Justification for Immediate Technical Specification Change

The attached amendment request to the PVNGS Unit 1 Operating License does not involve a significant hazard consideration because:

Safety Review and Evaluation of Proposed Technical Specification Amendment Dated May 31, 1985

Fuel Oil Specification

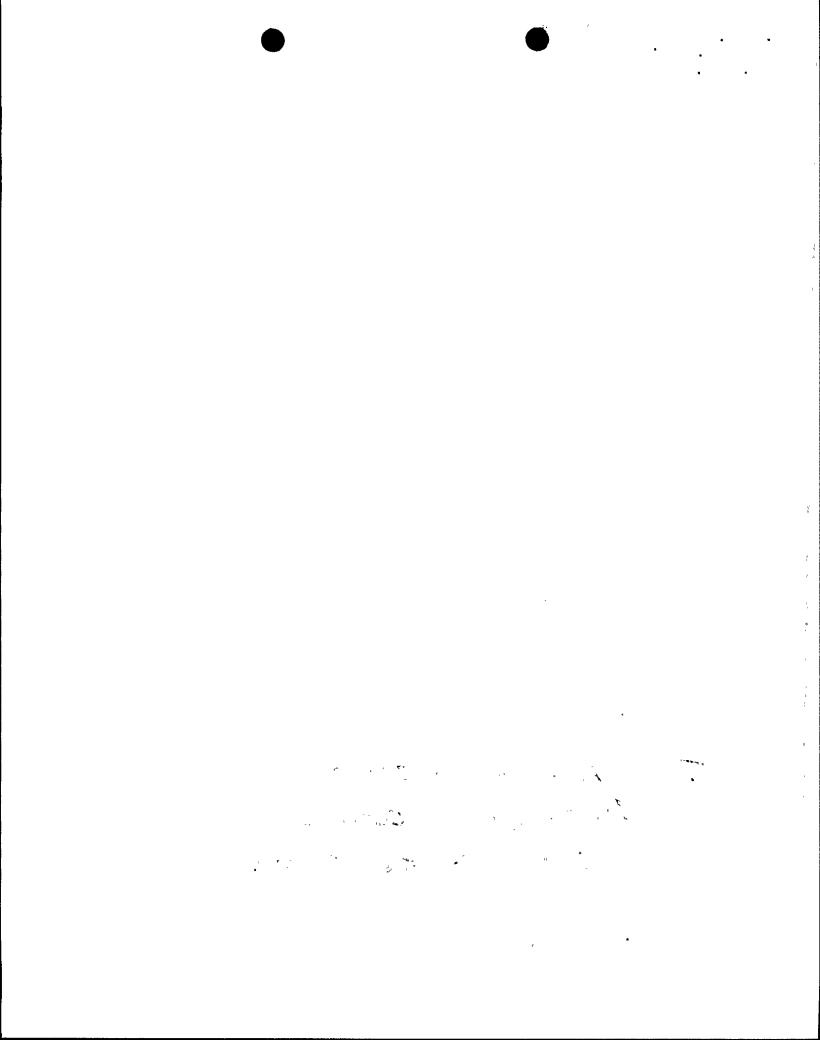
The diesel manufacturer has provided specific requirements for the fuel used in the system. These requirements are specified in the Tech. Manual for the diesels, and call for the use of "Light Fuel - ASTM D975-59T No. 1D or 2D." The specification identifies such parameters as Viscocity, Carbon Residue, Ash, Flash Point, Water and Sediment, Cetane Number, etc. The plant technical specifications also list the above specification requirements for the fuel, however in addition, the fuel is required to have an impurity level of less than 2 mg of insolubles per 100 ml when tested in accordance with ASTM D2274-70. a high temperature oxidation test in which fuel is prefiltered and then exposed to pure oxygen at high temperature (203 F) for 16 hours. The resultant deposits and solids are recovered and weighed. This test does not measure the the solids actually in the fuel - these are removed in the prefiltration step - but is intended to predict the oxidative stability of the fuel by severely accelerating the test conditions. The fuel which is in the diesel fuel storage tanks has consistently met all criteria listed for the components by the manufacturer. The fuel has not complied with the specifications for insolubles identified pursuant to ASTM D2274-70. In effect, the fuel complies with the manufacturers specification, however the existing specification requires the equipment be declared inoperable. This necessitates the removal of

NOTE: This page from specification M018-388-3, the Technical Manual for the Emergency Diesel Generators, as supplied by Cooper Energy Services.

Light Fuel - ASTM D975-59T No. 1D or 2D

Viscosity at 100F V 45 secs., Max. 32.6 Secs. Min. Carbon Residue on 10% residium .35% Max. Ash .02 Max. Flash 125F or legal Water and Sediment, % by volume 0.1 Cetane Number, Diesel 40 Min. 1.0 Max. Sulphur, % by weight Copper Strip Corrosion No. 3 Max. Distillation - 90% Point, F 540 Min., 675 Max. Pour Point, F 10F below ambient
